Euro Motorcars. Limited Site Plan Amendment. 82003014B

Limited Site Plan Amendment: 82003014B Euro Motorcars - Lot 1 (approximately 3.59 acres) is located at 19750 Germantown Road within the Germantown Employment Area Sector Plan, zoned TMX-2. This amendment will include an expansion of the showroom by 5,000 square feet in Building 3, a 2-story addition to the existing parking garage, relocation of entrance signage, and modifications to the Lighting and Landscape plans.

RECOMMENDATION AND CONDITIONS

*Proposed Building Elevation
(View from MD 118)*

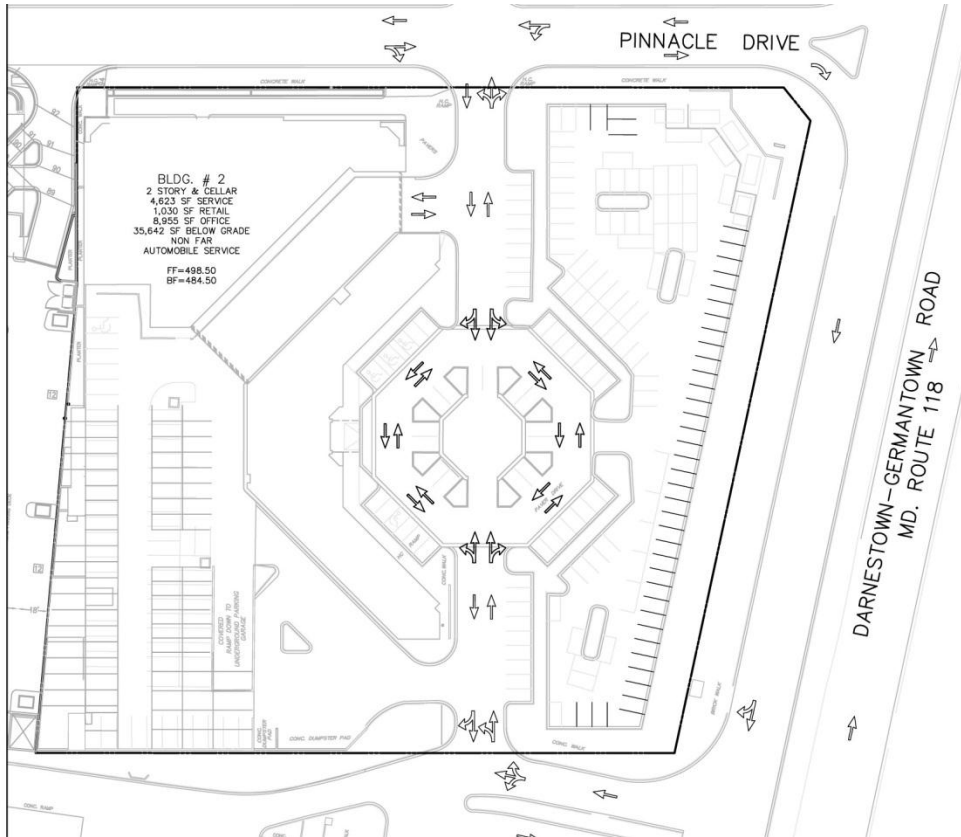
enhance the interior glass showroom area and accommodate more office and retail spaces along the front façade of the existing building.

The height of the existing parking garage (along the rear yards of Lots 1 and 2) will be increased by 2-stories in order to accommodate more onsite parking (above grade), and storage facilities (below grade). Motorcycle spaces (4) will be located within the parking garage, and bicycle spaces (12) will be located behind Building 3.

Proposed Circulation Diagram

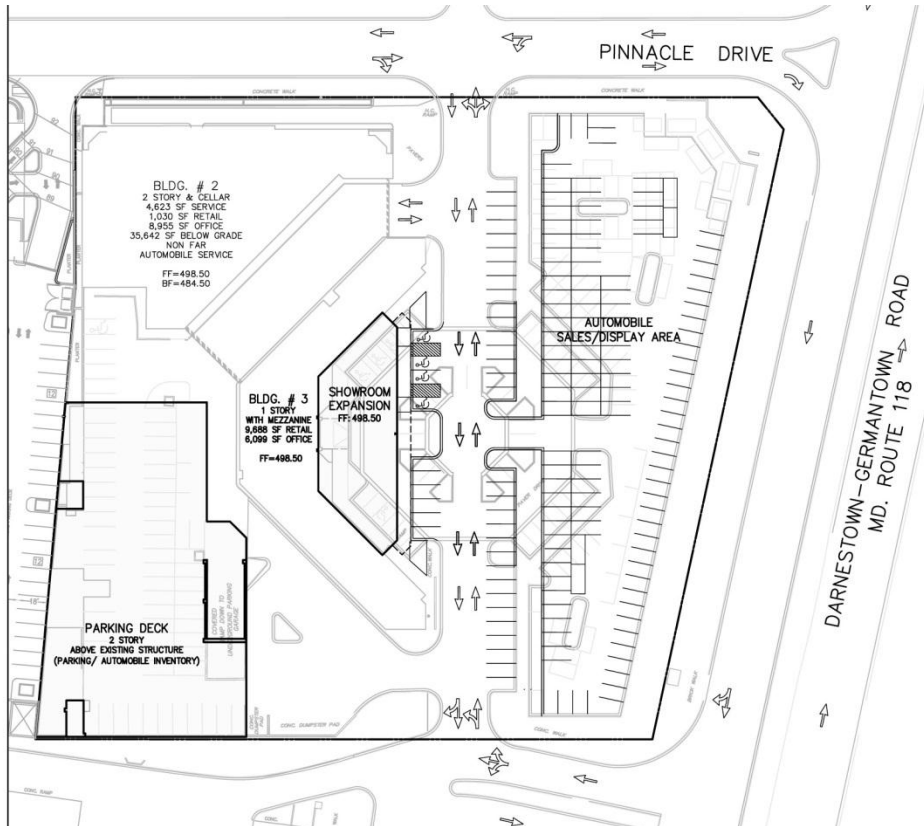
The primary access point is located along Pinnacle Drive. A secondary access point is available via a right-in/right-out driveway off of MD 118, which also serves the adjacent Safeway Shopping Center along the western property boundary. These access points will remain unchanged. The internal circulation is proposed to be modified in conjunction with the building expansion. The building shell of the proposed showroom will encroach into an area currently used as exterior display area; therefore, the octagonal design of the exterior display area will be eliminated and replaced with a straight connection from Pinnacle Drive to the shared driveway directly adjacent to the Safeway property.
